Clinton County Sanitary Landfill-East, South MSWLF Unit - 23-SDP-01-74P - DNR Comment Letter Response

SCS Engineers, on behalf of the Clinton County Area Solid Waste Agency, is submitting this response to DNR comments dated July 7, 2025 (Doc #113350) regarding the 2024 Annual Water Quality Report, dated January 29, 2025 (Doc #112063) for the South MSWLF unit at the Clinton County Sanitary Landfill-East.

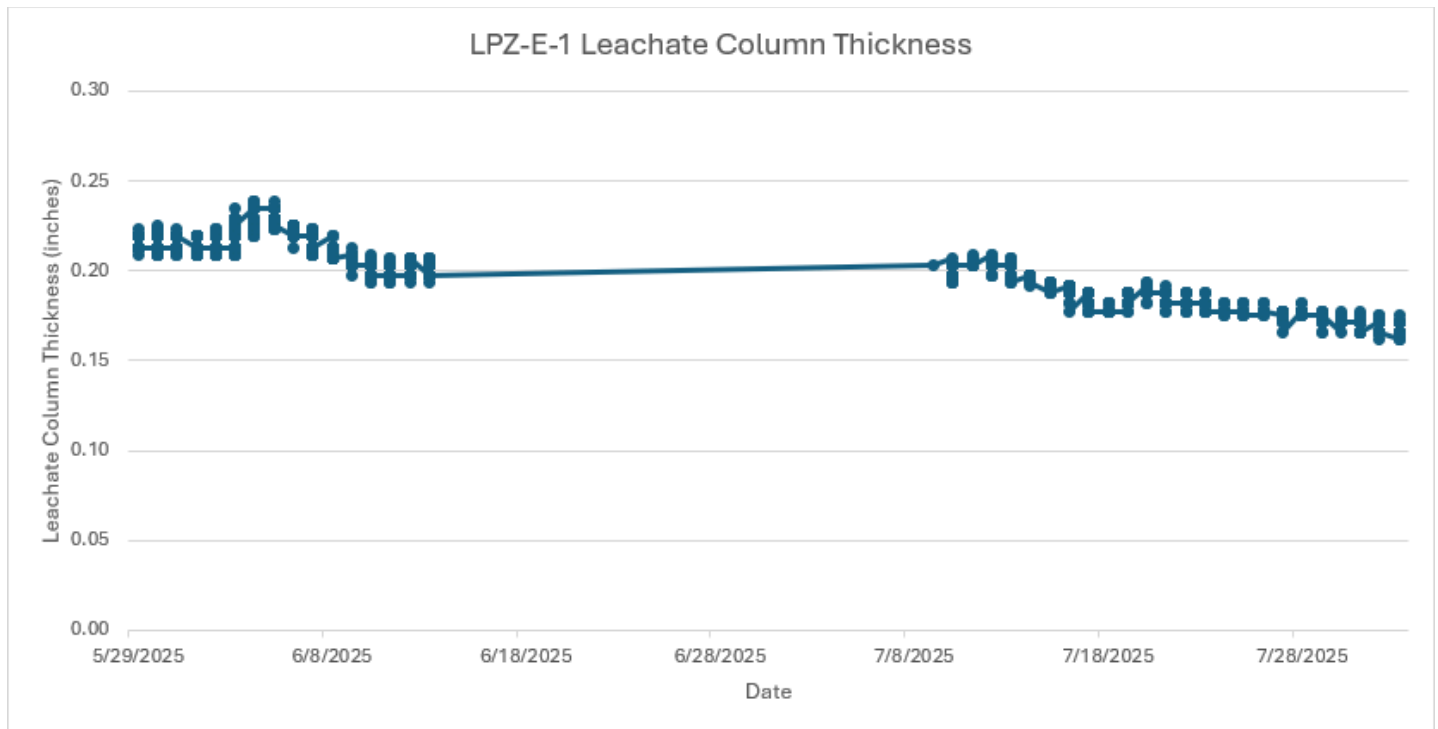
a. Please provide an update on the status of the leachate piezometers LPZ-1 and LPZ-E1.

The transducer that measured leachate levels in LPZ-E1 malfunctioned. After replacement of the transducer in May 2025, the SCADA system indicated leachate levels in the piezometer were below the compliance level. Recent data is shown in the graph below.
